## **Stage 1 Road Safety Audit**

**Residential Development, Cairns Road, Sligo**

On behalf of Novot Holdings Ltd

**March 2022**

### 3.3.4 Cairns Road – Utility Pole

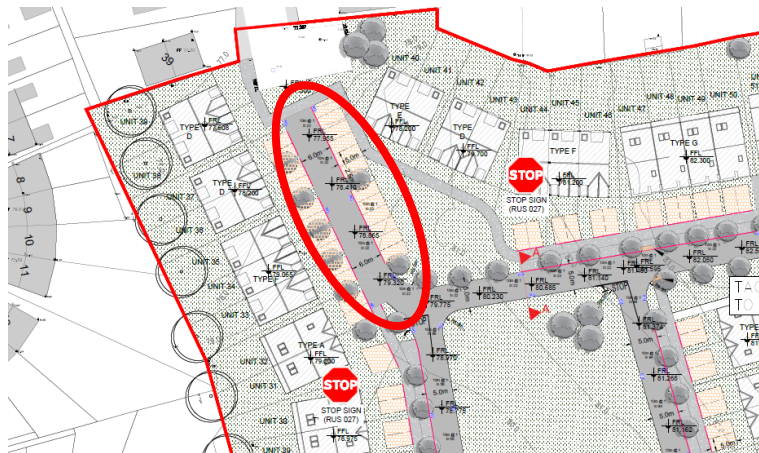
**Problem:** There is a utility pole within the carriageway adjoined to the development site. The existing stone wall to the south of the pole will be removed by the development.

**Hazard:** The existing wall may offer protection to the pole from northbound traffic. Removal of the wall may increase the risk of vehicle strikes of the pole.

**Recommendation:** Relocate the pole outside of the carriageway.

3.3.3	Yes	Yes	The proposed footpath now ties into the existing footpath as shown on the updated roads drawing.	
3.3.4	Yes	Yes	The Utility pole will be removed and services undergrounded along the proposed entrance as part of the works.

### 3.3.6 Junction control in front of Units 31/32

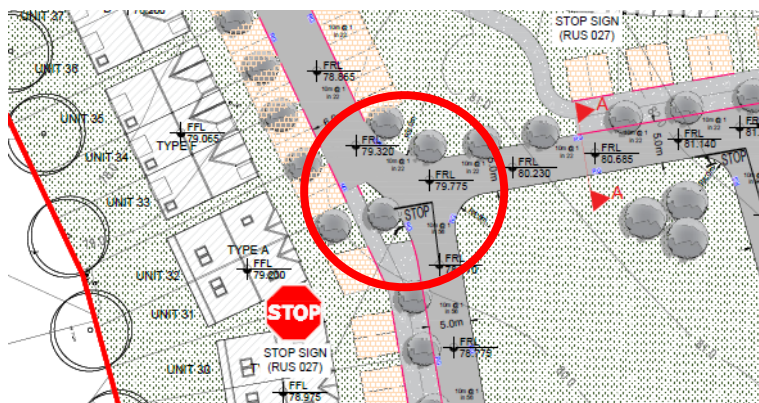
**Problem:** Further to Problem 3.3.4 above, users exiting a shared-use zone are likely to yield to all other users in the area, however motorists traveling north passing units 29-31 are instructed to stop at the junction.

**Hazard:** Users from both roads may initially stop waiting for the other to move, and then both may proceed at the same moment. Impact may result.

**Recommendation:** Amend the junction priority to show the stop sign / line on the shared-use area.

3.3.5	Yes	Yes	The proposed shared use area will consist of a raised table with flush kerbs and with a coloured surface course.	
3.3.6	Yes	Yes	The junction priority has been amended as per recommendations.
